I. Type of Well □ Oil Well ⊠ Gas Well	☐ Other	· · · · · · · · · · · · · · · · · · ·		Name and No. DD 23A FEDERAL 38	
2. Name of Operator Contact: REBECCA DEAL DEVON ENERGY PRODUCTION CO EPMail: REBECCA.DEAL@DVN.COM				9. API Well No. 30-015-35076-00-S1	
3a. Address 333 WEST SHERIDAN AVE OKLAHOMA CITY, OK 73102		Ph: 405-228-8429 SAN		Field and Pool, or Exploratory SAND DUNES

Additional data for EC transaction #308663 that would not fit on the form

Todd 23A Federal 38

Attached: Current and Proposed Wellbore Schematics.

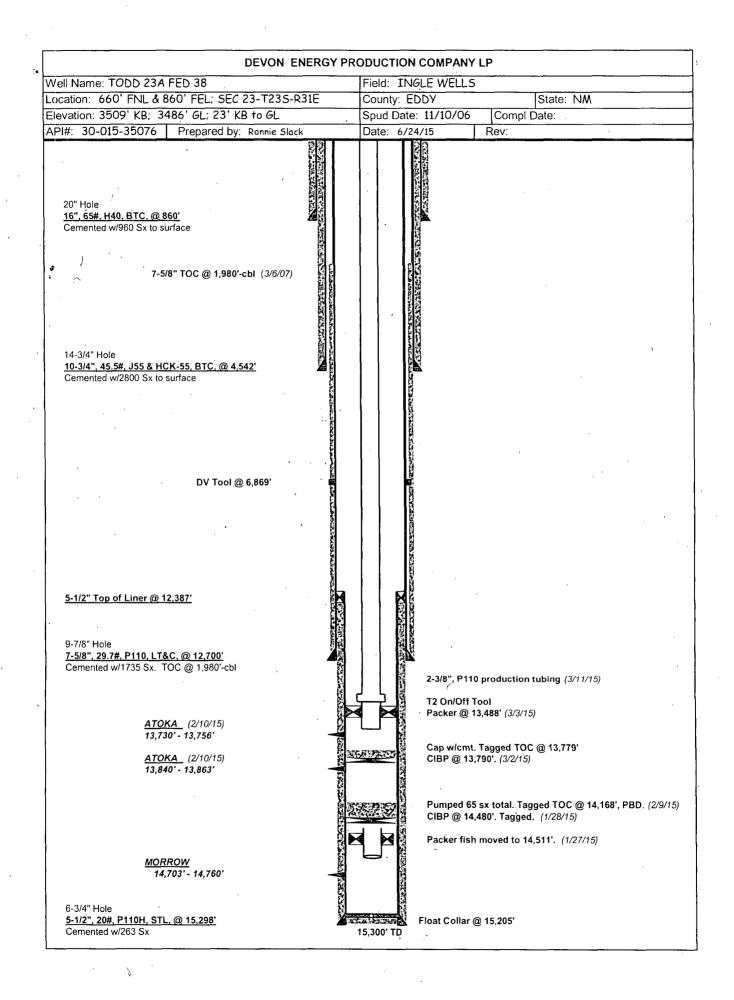
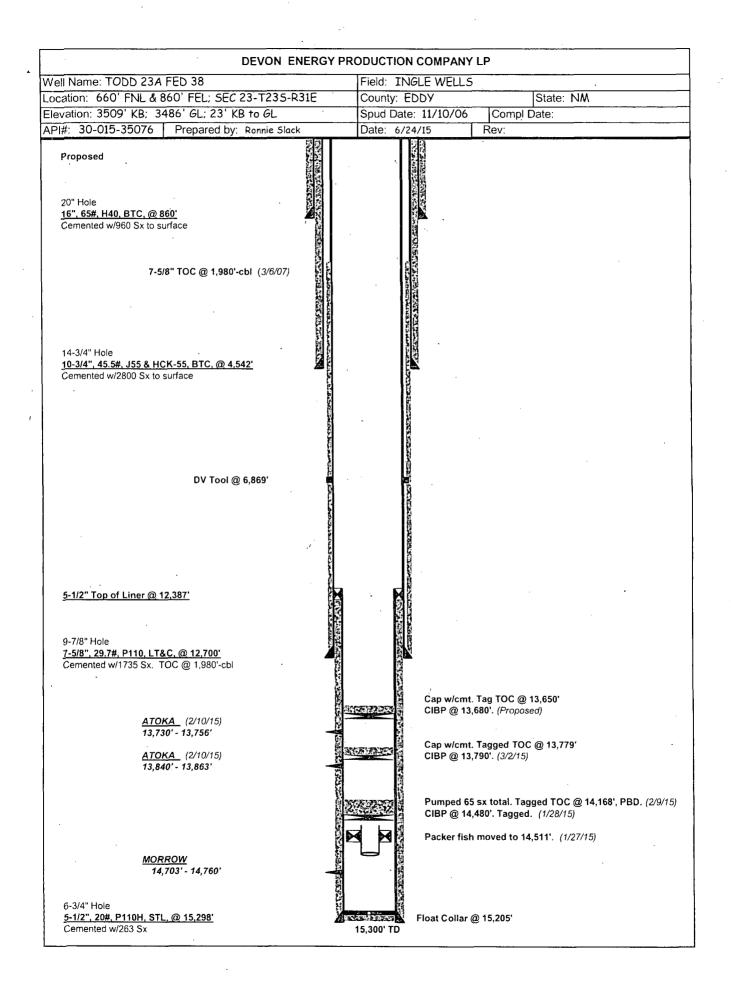
- 1. Operator shall set a CIBP at 13,680 (50' above top most perf) and <u>place 240' Class H</u> <u>cement on top.</u>
- 2. Operator shall place a solid Class H cement plug from 12,750'-12,337' to seal the 7-5/8'' casing shoe and the 5-1/2'' liner top. If operator desires this well to be a Wolfcamp producer this step can be done at a later date via sundry submittal.

<u>Note:</u> If operator does not produce from the Wolfcamp or Bone Spring formations a sundry will need to be submitted to properly plug back these formations.
